# Staff Report

Re: Detached Accessory Dwelling Unit – Conditional Use (PLNPCM2019-00412)

**PROPERTY ADDRESS:** Approximately 1143 South Lake Street

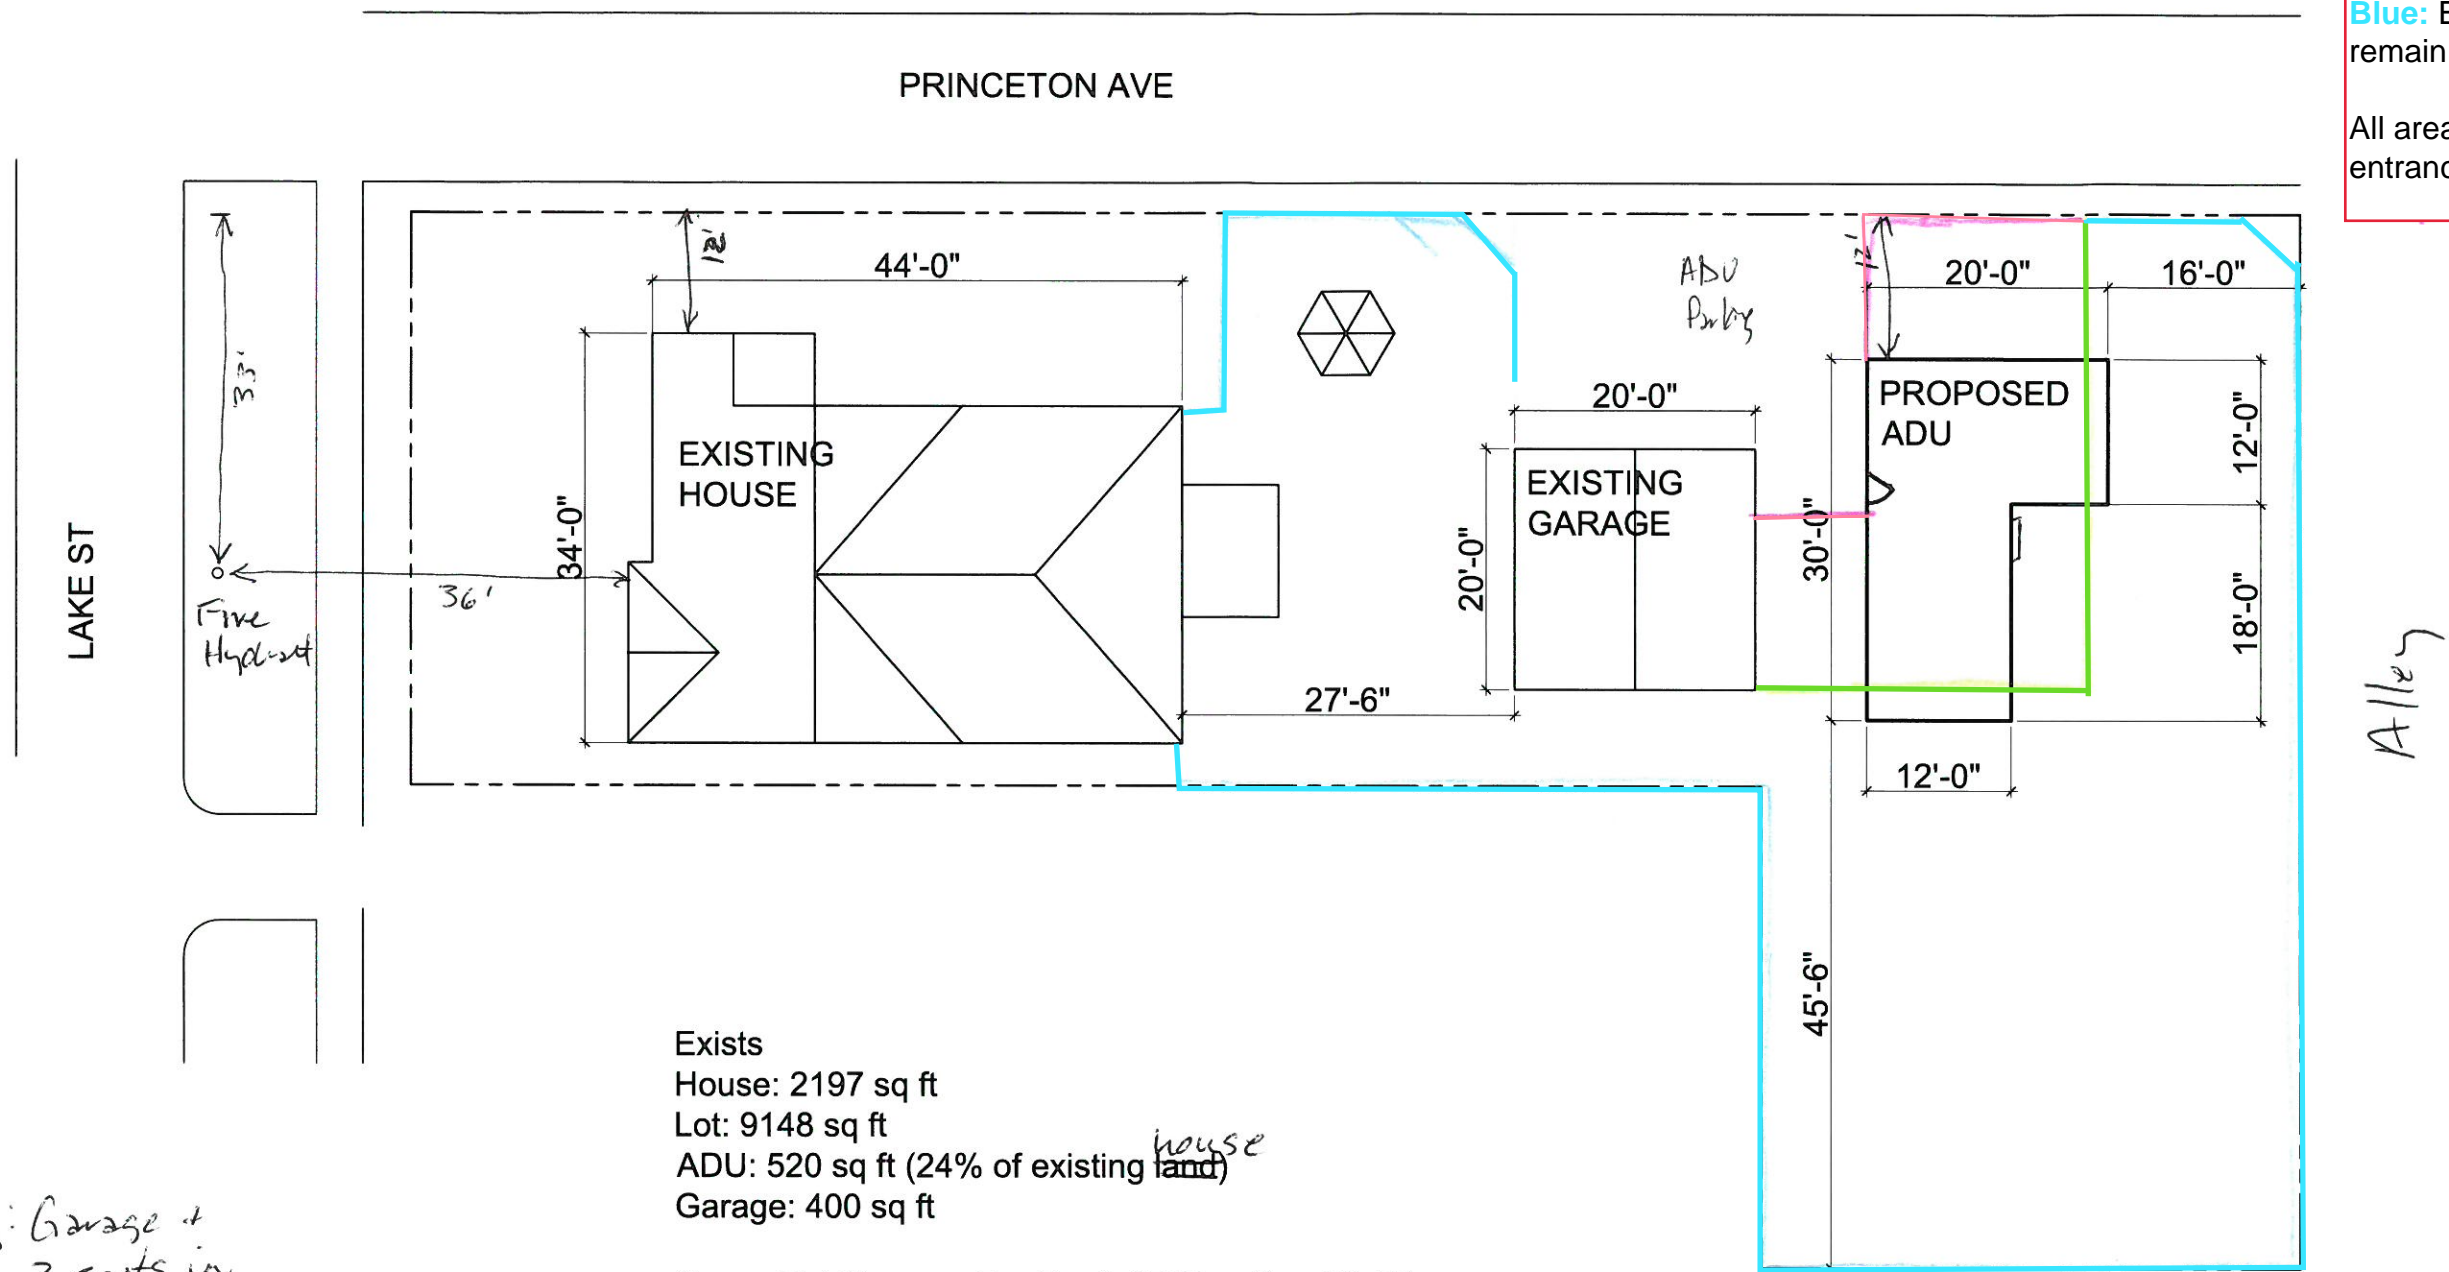
- Fire Apparatus access roads shall be within 150-feet to all exterior portions of the proposed structure. The site plan does not adequately show proposed fire apparatus access roads
- Fire hydrants shall be within 400 feet of all exterior walls of the structure. The site plan does not show existing or proposed hydrants.  
(All measurements are made in straight lines and right angles as the hose would be pulled or fire apparatus would be driven)

4. Owner needs to show some sort of ownership (County tax records, Title, etc.)
5. Customer must show a full site plan with all setbacks (from buildings and property lines), dimensions of buildings and dimensions of property lines.
6. The site plan (will not be accepted as a photograph) needs to show the 10' required side yard and that there will be no encroachments into this area other than building eaves.
7. Required 10' corner side yard must be maintained as landscaping/live vegetation. Please show this on the site plan. Also, on the site plan, please show the location of the AC unit and its setback from the property line.
8. Provide the lot coverage by solid roofed buildings which is not to exceed 40% according to section 21A.24.070.F.

9. The home requires 2 parking stalls and the ADU requires 1 parking stall (8' x 20'; 21A.40.200.E.1.g). All parking must be located (outside of the 10' buffer) in legal locations and be an improved surface (21A.44) – the Google Earth image of the property shows that the RV is parked on a gravel/an improved surface.

1. Provide drawn out site plan to include property line measurements from structure/ be sure to show true north
2. Any structure 5 feet or less must be fire rated in accordance to section R302 of the IRC with 5/8 type x gypsum board
3. Provide UL listed specifications for the proposed ventless washer/dryer combo
4. Provide section or side view of the two proposed skylights with measurements and curb height
5. Show radiant flooring design as stated in the project data on sheet #1
6. show drainage location for water heater
7. provide structural stamping or calculations from engineer
8. provide electrical plan
9. Will there be A/C installed if so please show specs and location on site plan

The updated site plan included in this staff report addresses these comments. Additionally, the applicant met with a permit technician to ensure compliance.

The updated site plan included in this staff report addresses these comments.
